ST. LUCIE PLANT UNIT 1 AND UNIT 2

IMPROVED TECHNICAL SPECIFICATIONS CONVERSION

ITS SECTION 3.9 REFUELING OPERATIONS

Revision 0

3.9.4, Shutdown Cooling (SDC) and Coolant Circulation – High Water Level

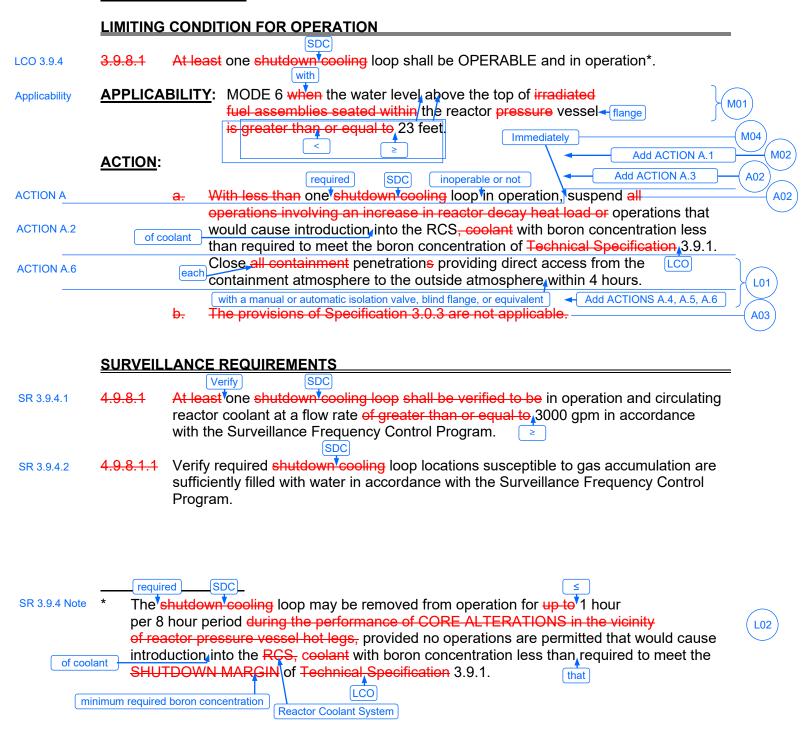
provide the requirements when water level is ≥ 23 feet and < 23 feet above the top of the irradiated fuel assemblies seated within the reactor pressure vessel, respectively. When water level is ≥ 23 feet above the top of the irradiated fuel assemblies seated within the reactor pressure vessel, only one SDC loop is required to be OPERABLE and in operation. When water level is < 23 feet above the top of the irradiated fuel assemblies seated within the reactor pressure vessel, two SDC loops are required to be OPERABLE, and one must be in operation. In ITS 3.9.4 and ITS 3.9.5, the equivalent ITS requirements, the water level reference point is the top of the reactor vessel flange, not the top of the irradiated fuel assemblies seated within the reactor pressure vessel. Changing this reference point effectively requires a larger complement of SDC loops to be OPERABLE between 23 feet above the top of the irradiated fuel assemblies seated within the reactor pressure vessel and 23 feet above the top of the reactor vessel flange. Therefore, this change is acceptable because more loops will be required to be OPERABLE under certain water level conditions to ensure the decay heat can be removed and the coolant circulated. This change is designated more restrictive because more SDC loops are required OPERABLE in the ITS under certain water level conditions than were required in the CTS.

The purpose of CTS 3.9.8.1 is to ensure that adequate decay heat removal and coolant circulation are available in MODE 6. Although decay heat is removed from the Reactor Coolant System via natural circulation to the bulk of water contained in the refueling cavity, this method of heat transfer can continue for only a discrete amount of time before boiling would occur. In addition, with no forced circulation, RCS flow may not be adequate to support coolant mixing to maintain uniform boron concentrations. This change is acceptable because it requires that action be initiated to restore the SDC loop requirements in order to restore forced coolant flow and heat removal. This change is designated as more restrictive because additional actions will be required in the ITS than are required in the CTS.

3/4.9.8 SHUTDOWN COOLING AND COOLANT CIRCULATION

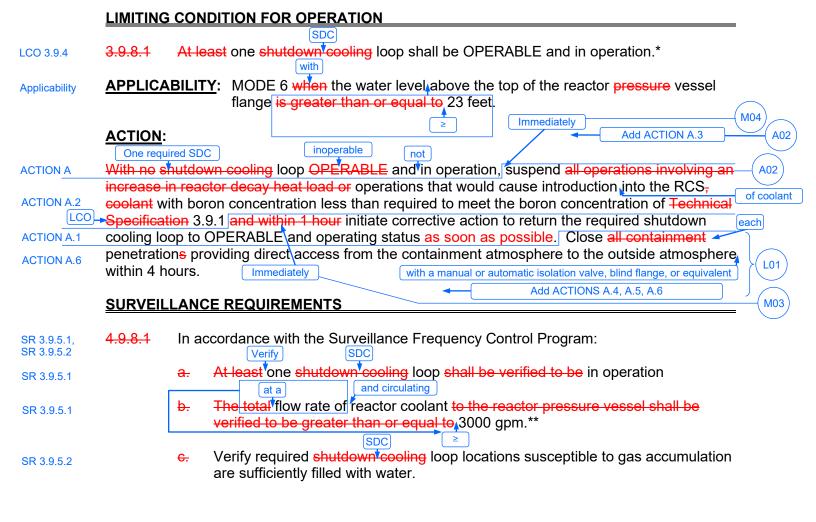
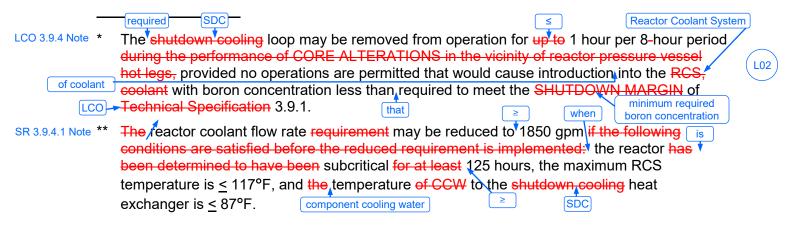
This change is acceptable because the requirements have not changed. The reactor decay heat load is generated only by irradiated fuel. The only method of increasing the decay heat load of a reactor in MODE 6 is to load additional irradiated fuel assemblies into the core. Therefore, the CTS and ITS requirements are equivalent. This change is designated as administrative because it does not result in technical changes to the CTS.

A03 **Unit 1 only:** CTS 3.9.8.1 Action b. states "The provisions of Specification 3.0.3 are not applicable." ITS 3.9.4 does not include this statement. This changes CTS by deleting the Specification 3.0.3 exception. This change is acceptable because the technical requirements have not changed. ITS LCO 3.0.3 is not applicable in MODE 6. Therefore, the CTS LCO 3.0.3 exception is not needed. This change is designated as administrative because it does not result in a technical change to the CTS.
